# Coastal Access – Tilbury to Southend-on-Sea

# November 2020

# 4. Representations and Natural England's comments on them

5A: MCA/TSE2/R/13/TSE0126 Site photo taken by Natural England of infrastructure steps to encourage public to use the crest of the seawall and the ECC signage attached to gateways on top of seawall at Parting Gut.

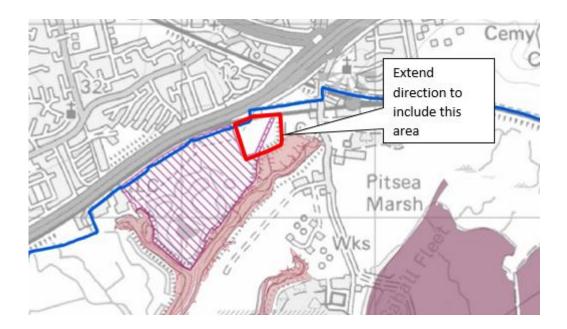
The proposed trail alignment is along the top of the seawall at the head of the creek called Parting Gut and the current route status is shown in the report as public footpath. However, this is not correct. The public footpath is actually along the folding behind the seawall. Therefore, either the trail alignment should be amended to follow the public footpath or the status of these sections should be changed to "Other existing walked route". During alignment discussions both the Essex Wildlife Trust and RSPB staff were keen that the trail route was kept off the top of the seawall either side of this location. Essex County Council would prefer the route to follow the existing public right of way along the folding.

Natural England note the comments made by Essex County Council regarding the discrepancy between the location of the definitive right of way on the folding and the proposed alignment of the England Coast Path.

Currently the public walk along to the crest of the seawall, facilitated by the infrastructure already in place on site (steps on seawall slope, gates on crest, see 'Supporting Documents') that suggests that this is currently being managed as a right of way. Natural England had taken the physical infrastructure and current use as the line of the right of way and not appreciated the small deviation in location. We will amend our maps to show this alignment as a current walked route on top of the seawall and continue to make use of the existing infrastructure in this location. This allows the public a chance to see the sea and associated habitats as for sections of the alignment either side of this section they are constrained to the folding to reduce the disturbance to wildlife in the intertidal area. The alignment on top of the seawall better meets the criteria laid out in the Scheme for the England Coast Path.
